STAFF REPORT
(Final Plat)

CASE NUMBER: S/D 90-25 - SOUTHCREST FOUNTAIN ADDITION

Re: S/D 90-25 - Plat of Southcrest Fountain Addition

VICINITY MAP:

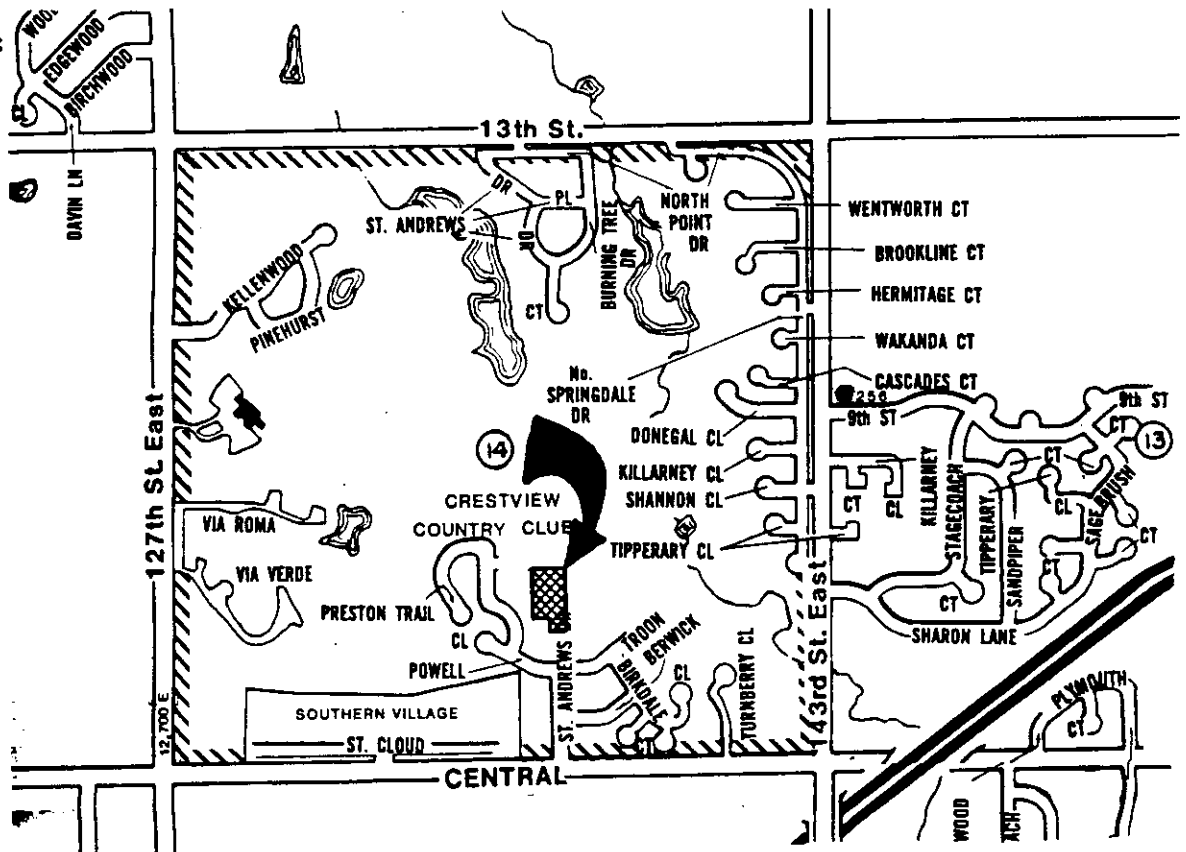
- A. The applicant shall guarantee the extension of City water to serve the lots being platted. Since this property will utilize a City of Wichita water supply line in St. Andrews Dr., the applicant shall submit an outside-the-City water service application and associated restrictive covenant.

- B. The applicant shall guarantee any drainage improvements required by the platting of this property.
- C. The applicant shall guarantee the paving of St. Andrews Drive to the interior north line of this plat with an appropriate temporary turnaround and to a standard similar to other streets in the general area.

- E. The final plat shall indicate an appropriate temporary turnaround for St. Andrews Drive. As required by County Engineering the temporary turnaround may be on or off-site.

- F. The final plat shall reference a tie point to a previously platted lot corner or section corner.
- G. The applicant shall install or guarantee the installation of all utilities and facilities which are applicable and described in Article 8 of the MAPC Subdivision Regulations.

- K. Prior to or at the time of submitting the final plat, the applicant shall submit a drainage plan to County Engineering for review and approval.

- L. The representatives from the utility companies should be prepared to comment on the need for utility easements to be platted on this property.
 - M. The representative from County Engineering should be prepared to comment on the status of the applicant's drainage concept. the County Engineer shall also verify that sanitary sewer along this plat's west line can be utilized by this Addition.
-
